10/797,452

Advisory Action Before the Filing of an Appeal Brief	Application No.	Applicant(s)	
	10/797,452	BAGHDADI ET AL.	
	Examiner	Art Unit	
	Vishal Patel	3673

THE REPLY FILED 27 December 2006 FAILS TO PLACE THIS APPLICATION IN CONDITION FOR ALLOWANCE.

LABYRINTH GLAND CONSTRUCTION

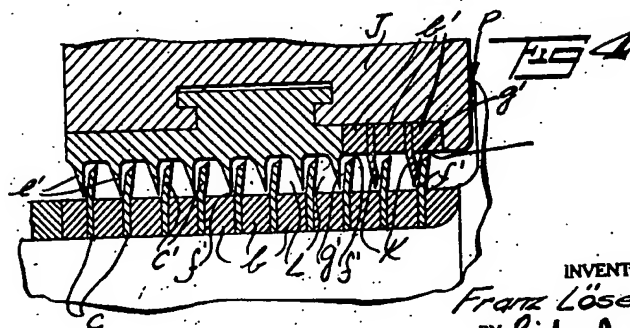
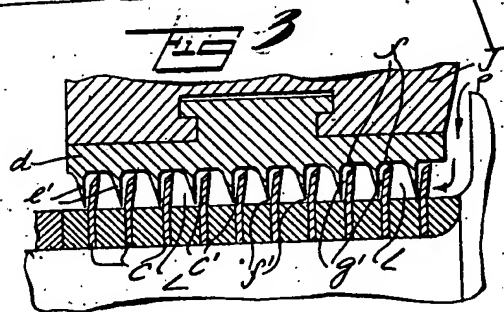
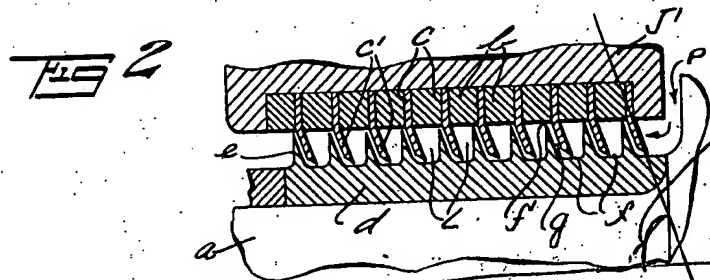
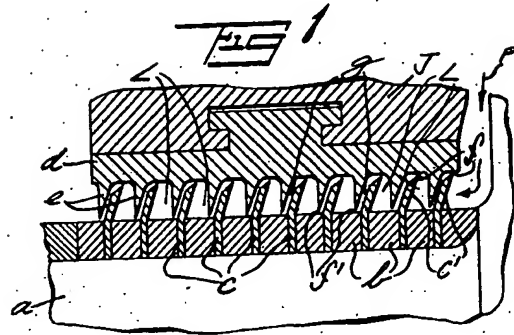
Continuation of 11. does NOT place the application in condition for allowance because: Applicants' argument against Groos, Bunker and Losel is not persuasive because as stated in the rejection Gross teaches blades on stationary and rotary bodies, Bunker teaches that the blades on the rotary body are at an acute angle relative to the rotational axis and Losel teaches that the blades on the stationary body are at an acute angle relative to the rotational axis (see attached figure).

Acute Angle

Rotational Axis
